Product Change Notice (PCN)

PCN Number: PCN-0451205R-01

Product(s) Affected: PJ-057BH

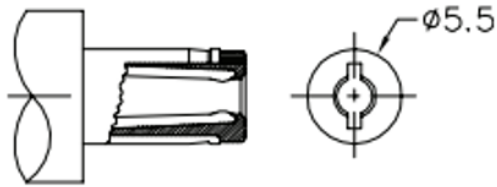
Description of Change: *Minor Housing and footprint differences. Material Change on the housing and terminals. See image Below*

PREVIOUS CUI DEVICES DETAIL / IMAGE			NEW CUI DEVICES DETAIL / IMAGE		
	MATERIAL	PLATING	DESCRIPTION	MATERIAL	PLATING/COLOR
center pin	copper	nickel	center pin	brass	nickel
terminal 1	brass	silver	terminal 1	brass t=0.40	silver
terminal 2	copper alloy	silver	terminal 2	bronze t=0.30	silver
terminal 3	brass	silver	terminal 3	brass t=0.40	silver
plastic	PBT		cover	PA10T (UL94V-0)	black
			housing	PA10T (UL94V-0)	black

MATING PLUG
Jack Insertion Depth: 9.15 mm

MATING PLUG
Jack Insertion Depth: 9.45 mm
